UCS Perspectives on Part 53

**Dr. Edwin Lyman
Director of Nuclear Power Safety
Climate and Energy Program
Union of Concerned Scientists**

July 21, 2022

Decrease in Average Core Damage Frequency

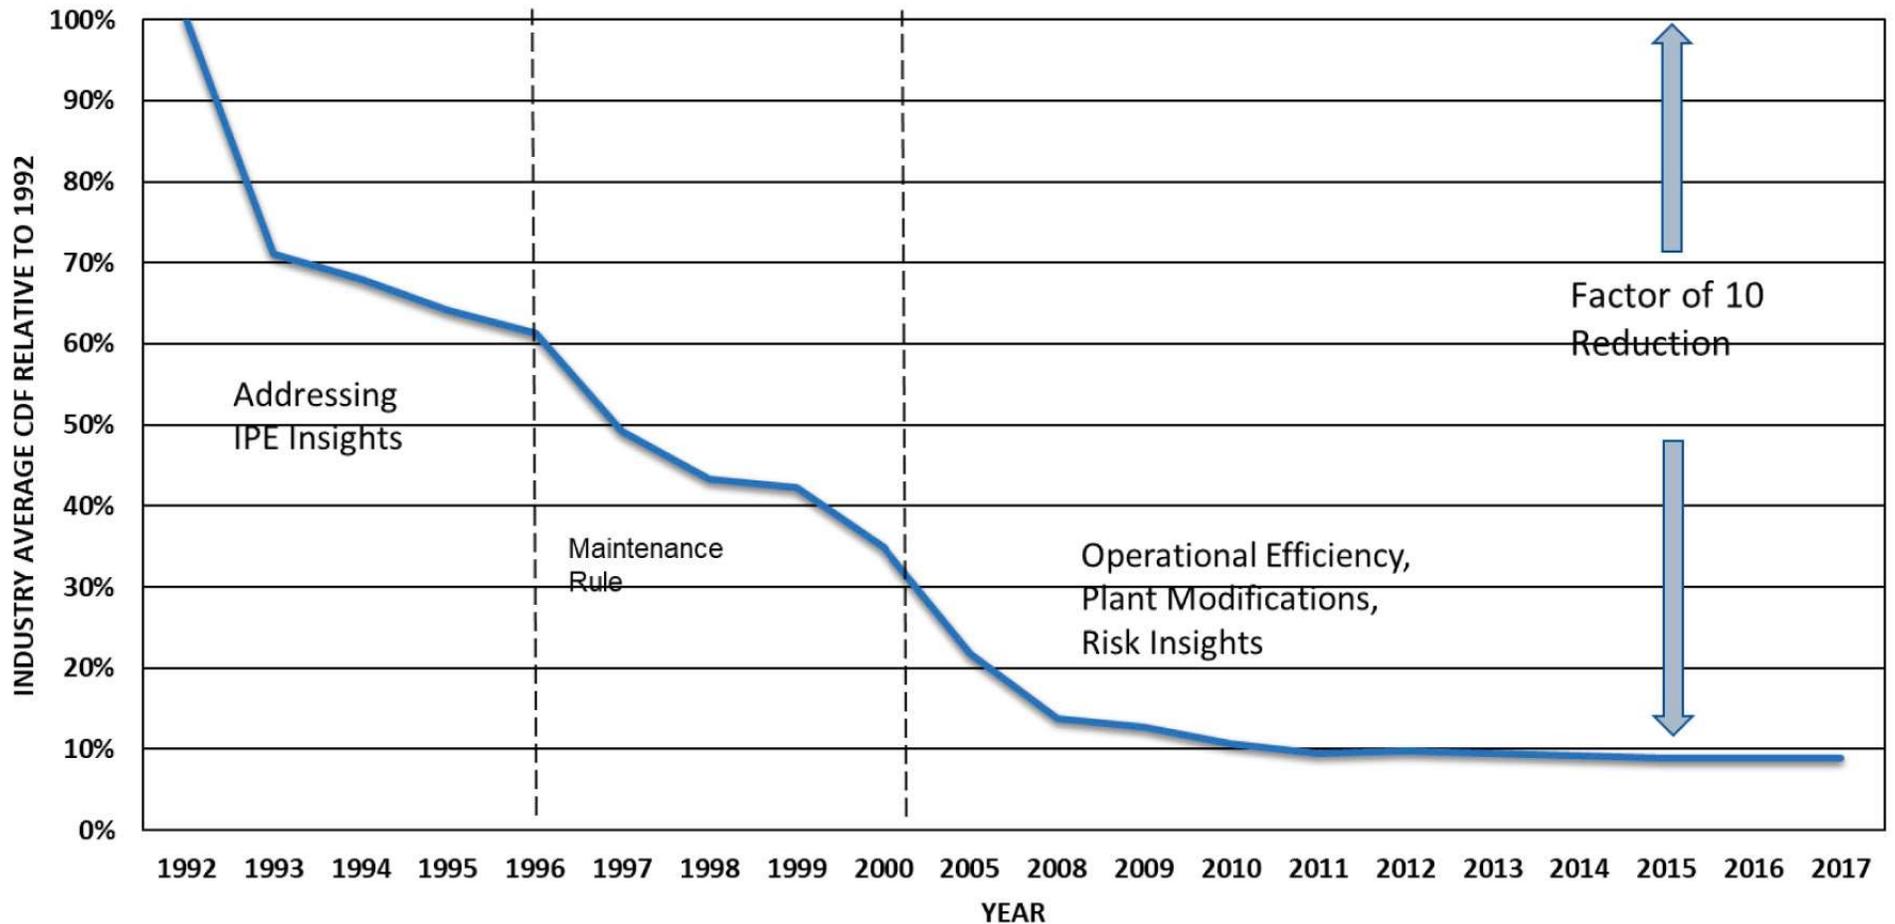
Margin to QHOs has increased

- Part 53 does need specific, quantitative acceptance criteria for limiting the risk of (non-DBA) LBEs, but the QHOs are not the right ones
- QHOs represent the (minimum) level of safety of the fleet as it was 30 years ago
- SRM-SECY-89-102 (Implementation of the Safety Goals) pointed out that operating plants circa 1990 already met the QHOs with margin
- Today's operating plant average core damage frequency is 10 times lower than in 1990
 - Vogtle Level 3 PRA finds a hundred-fold margin to the latent cancer fatality QHO and a million-fold margin to the prompt fatality QHO
